The Sizewell C Project

9.28 Comments on Written Representations

Revision: 1.0
Applicable Regulation: Regulation 5(2)(q)
PINS Reference Number: EN010012

June 2021

Plate 16.1: Recorded Crime per 1,000 residents per month at force level (5 year average) (Police.uk)

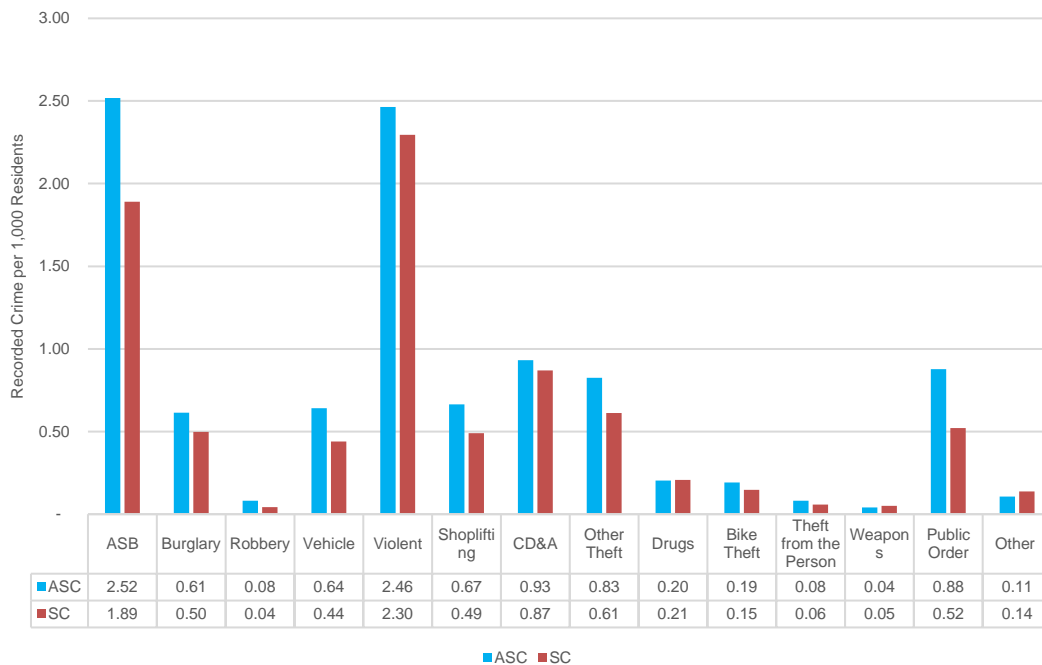
- 16.2.8 SZC Co. agrees that there are differences between the areas, but the differences in crime rates are not very large and tend to be higher in Avon and Somerset and around Bridgwater, as shown in **Plate 16.1** and **Plate 16.2**.

Plate 16.3: Recorded Crime and Population (and HPC NHB Workers) in Bridgwater / West Somerset Constituency (Police.uk)

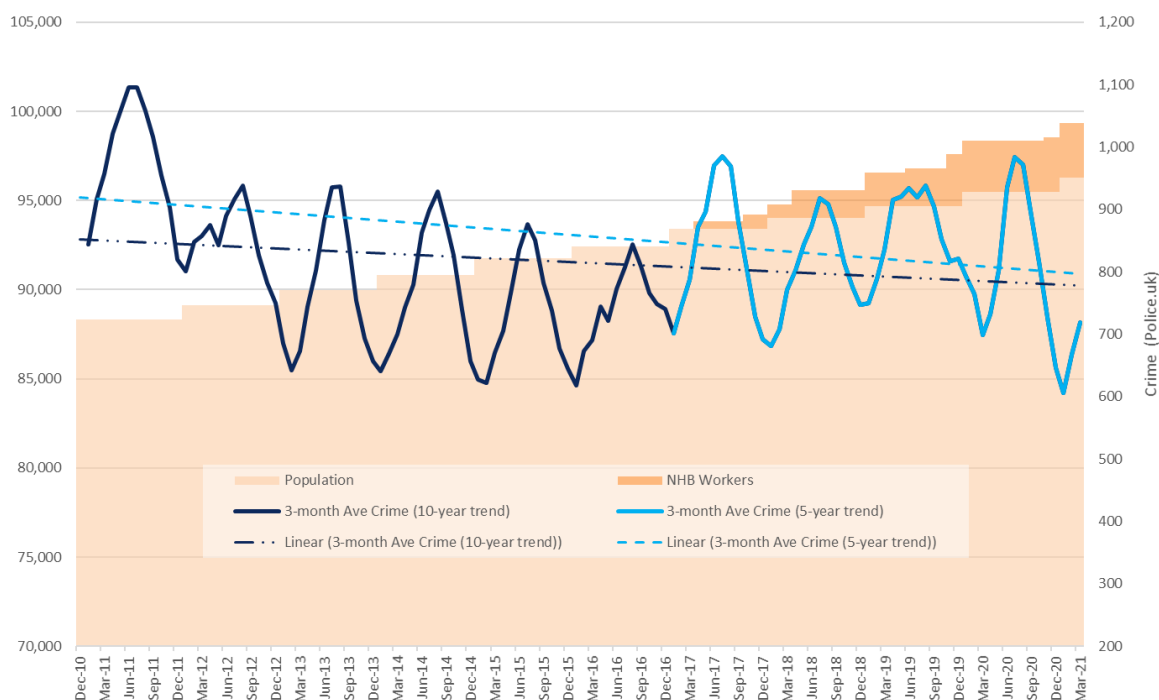
16.2.23 There is also no evidence to show that crime rates in general (whether attributed to Hinkley Point C or not) are rising. The data for Bridgwater and Somerset West (see **Plate 16.3** below) show that crime has been falling for 10 years and that the rate of decline has increased since the Hinkley Point C Project started. This does not suggest that there is significant additional crime in the area as a result of the Hinkley Point C Project.

Plate 16.4: Recorded Crime and Population (and HPC NHB Workers) in Bridgwater / West Somerset Constituency (Police.uk)

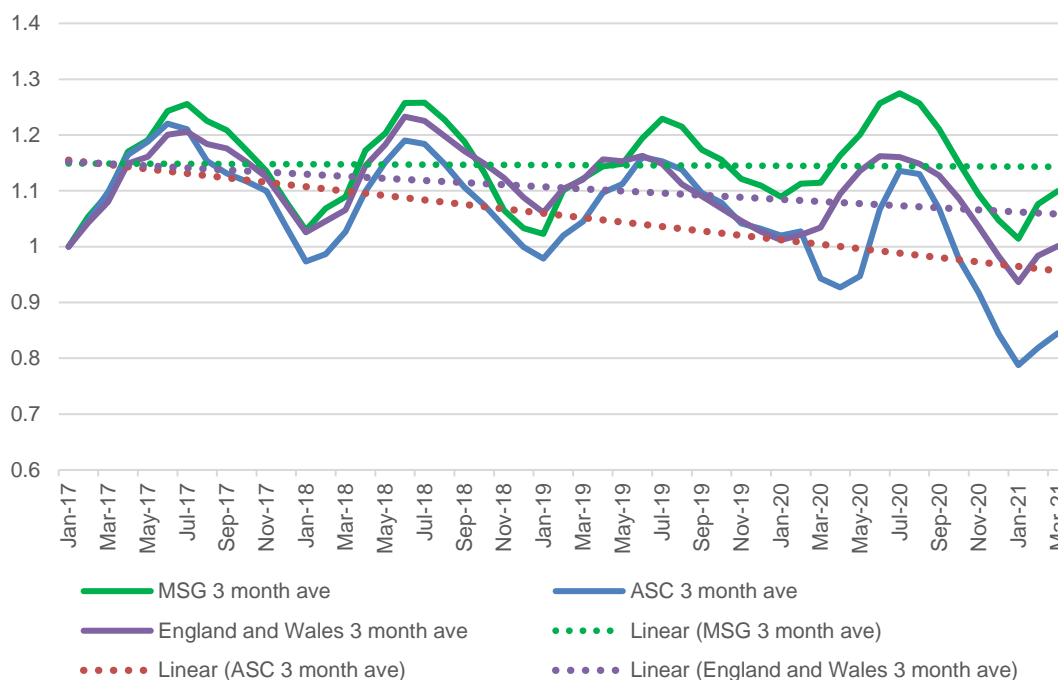
16.2.24 Similarly, there is no evidence that crime in Avon and Somerset is increasing when compared to a background trend. Police forces are grouped for the purposes of comparison into “Most Similar Groups.” This is based on a number of demographic factors that correlate with crime. ASC is in a group with Essex, Kent, Sussex, Hertfordshire, Hampshire, Staffordshire and Derbyshire. **Plate 16.4** shows that the five-year trend of crime (indexed) has a greater rate of decrease in ASC than the national or the Group average.
